# Access Compliance Report

## Public Rights-of-Way

### (Curb Ramps)

Intersection ID: 10040463	Main Street: VIZCAYA_CT	Cross Street: N/A	Location: W
ADA ID: 5FBFD9F6E3E3	Ramp Type: Perp	Initial Pass/Fail: Fail	Overall Compliance: No
Codes/Mitigation Info/Possible Solution		Field Measurements/Component Compliance	
Severity Score: 12.5

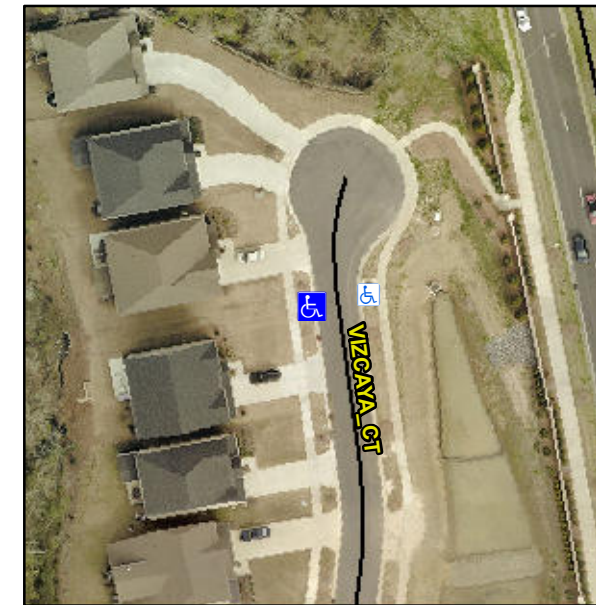
Compliance	Description	Data	Compliance	Description	Data
N/A	Ramp Length (in)	102.0	No	Ramp Slope (%)	8.6
Yes	Ramp Width (in)	48.0	Yes	Ramp XSlope (%)	1.1
N/A	Flare Type LT	N/A	N/A	Flare Type RT	N/A
N/A	Flare Slope LT (%)	N/A	N/A	Flare Slope RT (%)	N/A
N/A	Flare Traversable LT?	N/A	N/A	Flare Traversable RT?	N/A
N/A	Landing Length (in)	N/A	N/A	DWS Provided?	N/A
N/A	Landing Width (in)	N/A	N/A	DWS Contrast?	N/A
N/A	Landing Slope (%)	N/A	N/A	DWS Length (in)	N/A
N/A	Landing X Slope (%)	N/A	N/A	DWS Full Width?	N/A
N/A	Landing Curb? (Y/N)	N/A	N/A	DWS Offset (in)	N/A
N/A	Shared Landing?	N/A			
N/A	Gutter Ponding?	N/A	N/A	Gutter Slope (%)	N/A
N/A	Gutter Lip Ht (in)	N/A	N/A	Gutter X Slope (%)	N/A
N/A	Painted X Walk1?	No	N/A	Painted X Walk2?	N/A
	X Walk 1 Direction	To E		X Walk 2 Direction	N/A
N/A	X Walk 1 Width (in)	N/A	N/A	X Walk 2 Width (in)	N/A
	X Walk 1 Slope (%)	3.5		X Walk 2 Slope (%)	N/A
	X Walk 1 X Slope (%)	0.0		X Walk 2 X Slope (%)	N/A

**Remove & Replace Entire Ramp.**

**R304.2.2**
